Older Model TLS-2/3 Transmission Level Modification for High Speed Modems

These relatively simple changes to the TLS-3 solve high speed modem problems (errors caused by impedance mismatch and echo).

Figure 1 Schematic Diagram

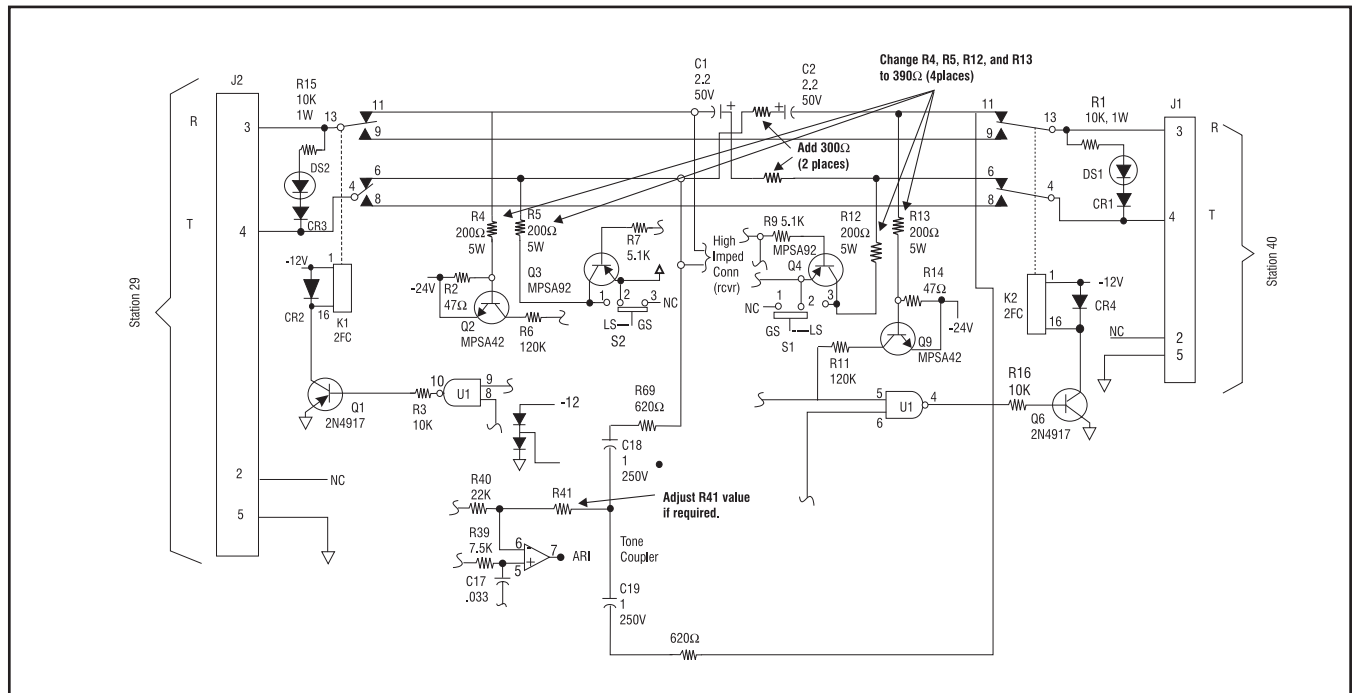
The change would move the TLS-3 impedance toward 600Ω, increase the insertion loss (end-to-end) from around 2 dB to around 8.5 dB (600Ω). (Similar to end-to-end loss on two more or less average subscriber lines.) There are two known regrettable shortcomings.

1. A decrease in available loop current.
The resultant loop current will still be more than 29 mA, but will not support extended loop lengths.
2. Dial tone and busy tone level will be increased.
This can be corrected by an additional value change, but it appears to be equalized between the two ports.

1. Change the battery feed resistance from 200Ω (per side) to 390Ω. This increases the basic line impedance. Change resistors R4, R5, R12, and R13 to 390Ω with a 5 watt power rating.
2. Add 300Ω resistors in series with each of the line-to-line coupling capacitors, C1 and C2, to decrease the end-to-end loading on the signal source, and inject the end-to-end loss. Lift the positive side of each capacitor and add the 300 Ω ½W resistor.
3. Change the value of R41 to correct the dial tone level for the new line impedances, if required. R41 is selected from between 51 KΩ and 270 KΩ during assembly to achieve a dial tone level of 92-164 mVRMS per tone into a 600Ω load (approximately -18 dBm).
